Access Compliance Report

Public Rights-of-Way

(Curb Ramps)

Intersection ID: 12082	Main Street: ALLEN_ST	Cross Street: E_16TH_ST	Location:	N
ADA ID: EBE8096BE67D	Ramp Type: Directional1	Initial Pass/Fail: Pass	Overall Compliance: No	Severity Score: 2.5
Codes/Mitigation Info/Possible Solution		Field Measurements/Component Compliance

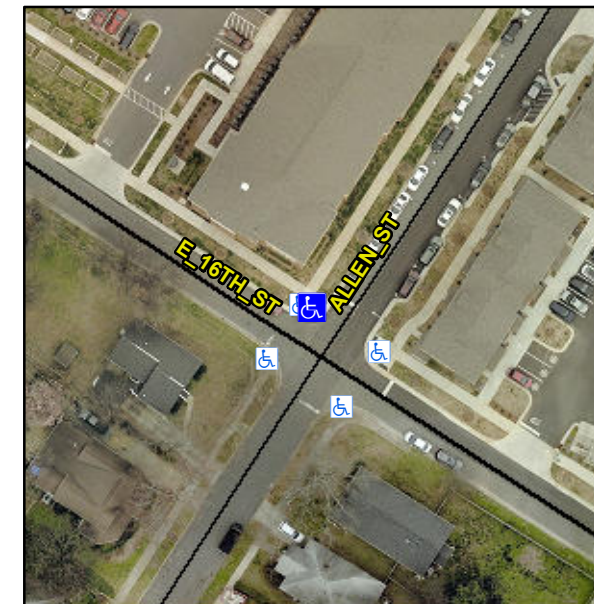
**Not Found, R304.2.2-Perp, R304.3.2-
Para, R304.5.3, R305.1.4, R305.2**

Compliance	Description	Data	Compliance	Description	Data
N/A	Ramp Length (in)	72.0	Yes	Grade Break?	Yes
Yes	Ramp Width (in)	56.0	No	Grade Break Slope (%)	8.9
Yes	Ramp Slope (%)	6.4	No	Grade Break XSlope (%)	3.1
Yes	Ramp XSlope (%)	1.9			
Yes	Flare Type LT	N/A	Yes	Flare Type RT	N/A
N/A	Flare Slope LT (%)	N/A	N/A	Flare Slope RT (%)	N/A
N/A	Flare Traversable LT?	No	N/A	Flare Traversable RT?	No
Yes	Landing Length (in)	67.0	Yes	DWS Provided?	Yes
Yes	Landing Width (in)	71.0	Yes	DWS Contrast?	Yes
No	Landing Slope (%)	4.2	Yes	DWS Length (in)	24.0
No	Landing X Slope (%)	2.7	No	DWS Full Width?	No
N/A	Landing Curb? (Y/N)	N/A	Yes	DWS Offset LT (in)	6.5
N/A	Shared Landing?	Yes	No	DWS Offset RT (in)	2.5
Yes	Gutter Ponding?	No	Yes	Gutter Slope (%)	1.0
Yes	Gutter Lip Ht (in)	0.0	No	Gutter X Slope (%)	2.9
N/A	Painted X Walk1?	No		Road Slope (%)	4.6
	X Walk 1 Direction	To SE		Road X Slope (%)	4.2
	X Walk 1 Width (in)	N/A		Clear Space?	Yes

**Remove & Replace Entire Ramp.
Remove & Replace Gutter.**
